**AEROSPACE STANDARD**

GASKET, RUBBER, FLUID RESISTANT,  
OILS, SYNTHETIC OILS AND FUELS  
(-65 TO +400 °F), MOLD IN GROOVE

**SAE AS27196A**  
SHEET 1 OF 2

FIGURE 1

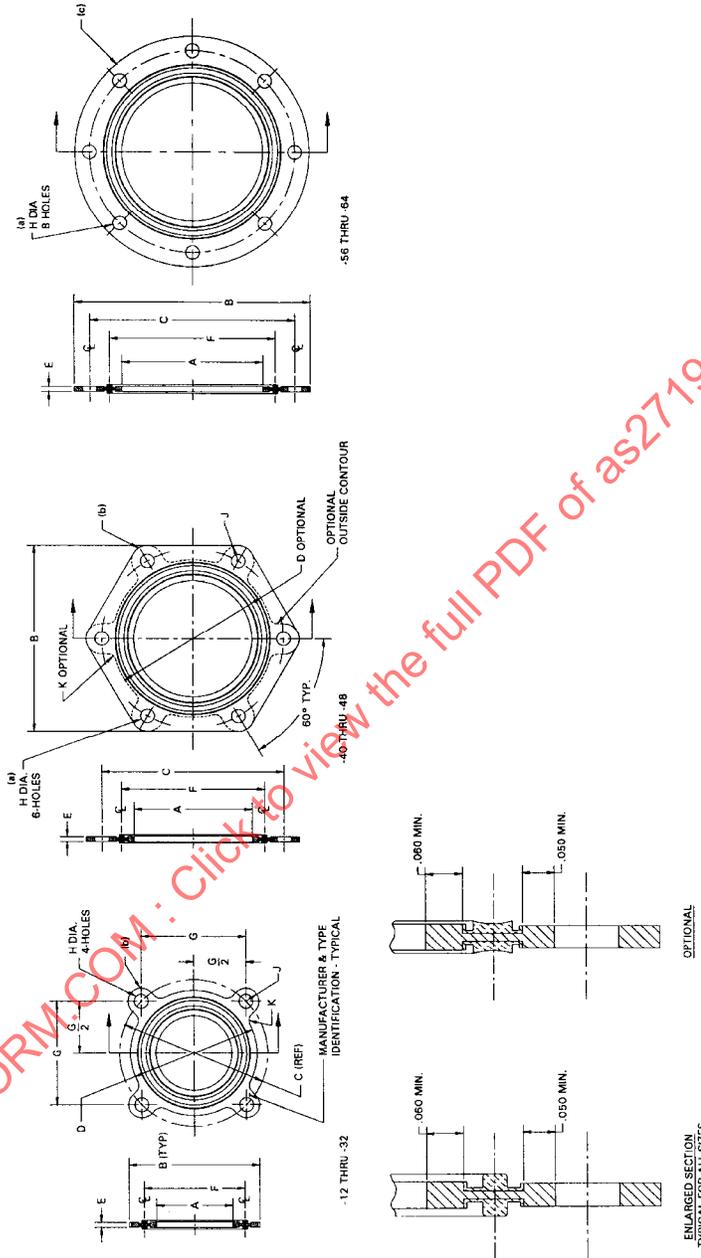
WHEN MS27196 WAS CONVERTED TO AS27196 THE PLATE MATERIAL WAS UPDATED FROM MIL-S-5059 302 ANNEALED TO AMS 5515. MIL-S-5059 CANCELLATION NOTICE 1 STATES THAT 302 ANNEALED WAS REPLACED BY AMS 5516. THIS REVISION CORRECTS THAT ERROR.
